**Flood Control Project Maintenance
Levee Inspections**

Maintenance Issue Types Only, Levee Inspection Report By Mile - Fall 2019

Reclamation District No. 2058 Pescadero

Waterway	Bank	Unit Miles	Inspection Start/End	Inspector
Unit No. 01 Paradise Cut	Left	6.58	10/21/2019 10/21/2019	Alberto De Leon

Photo 1 of 3 : SJR2019_RD2058U01RM3.97_1.jpg

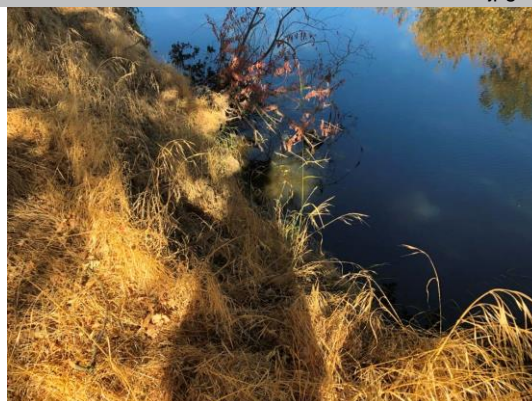
LM Start	4.43	Rating **	M	Issue No.	1
LM End	4.47	Issue Type +	Ma	Location *	
Category	Supplemental		GPS Latitude/Longitude		
			Start	End	
Item	DWR Erosion Survey		37.789810°	37.789810°	
			-121.352490°	-121.352490°	
DWR ID	RD2058U01RM3.97

Site ID: RD2058U01RM3.97
 09/25/2019: No significant change observed.
 10/10/2017: No significant change observed.
 07/20/2016: No significant change observed.
 08/04/2015: No significant change observed.
 08/26/2014: No significant change observed.
 08/28/2013: No significant change observed.
 07/26/2012: The site has been visited, and no significant change has been observed.
 09/02/2011: This site was not visited due to the time limit.
 09/22/2010: No significant change observed. Minor pocket erosions are lined at the lower bank. Two large Oak and Willow trees are on mid-slope and bench. The remaining bench was re-measured and found to be approximately 10 feet. There was no indication of active erosion on site during the site visit.
 08/05/2010: Recommended for annual assessment and monitoring of the site during flood events, per CLRO.
 07/23/2009: No major change observed since last visit; site is a 200-ft. long near-vertical berm erosion; recommend annual assessment and monitoring of the erosion site, per CLRO CES Evaluation 2008 Report; Site # is the same site previously reported as RM4.0, LM4.51; previously rated "U".

09/10/2008: Two large trees (2-3' DBH) with partial roots exposed.
 2007: Visited site 03/13/2007.

Direct view of the pocket erosion site.

Photo 3 of 5 : FA_2019_RD2058_111_40_20190830_00024.jpg

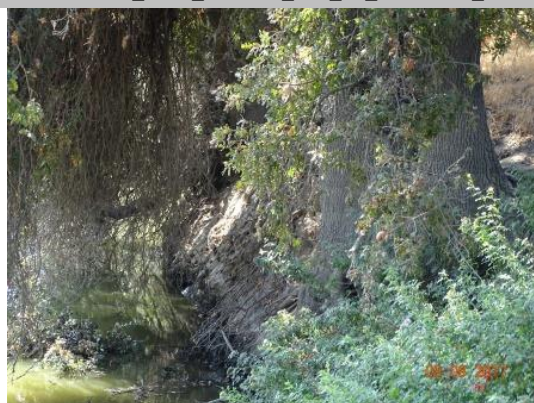
LM Start	4.63	Rating **	A/W	Issue No.	40 (cont)	
LM End	4.76	Issue Type +	Ma	Location *	WS	
Category	Earthen Levee			GPS Latitude/Longitude		
				Start		End
Item	Erosion / Bank Caving			37.787756 °		37.785971 °
				-121.350851 °		-121.350372 °
DWR ID	DWR_RD2058_01_f_2017_40					
Comment Code						
E2 : Schedule repair of erosion site prior to the next inspection.						
Inspector Comment						
Erosion on the waterside is greater than three feet tall into the levee prism.

Upstream view of the erosion site.
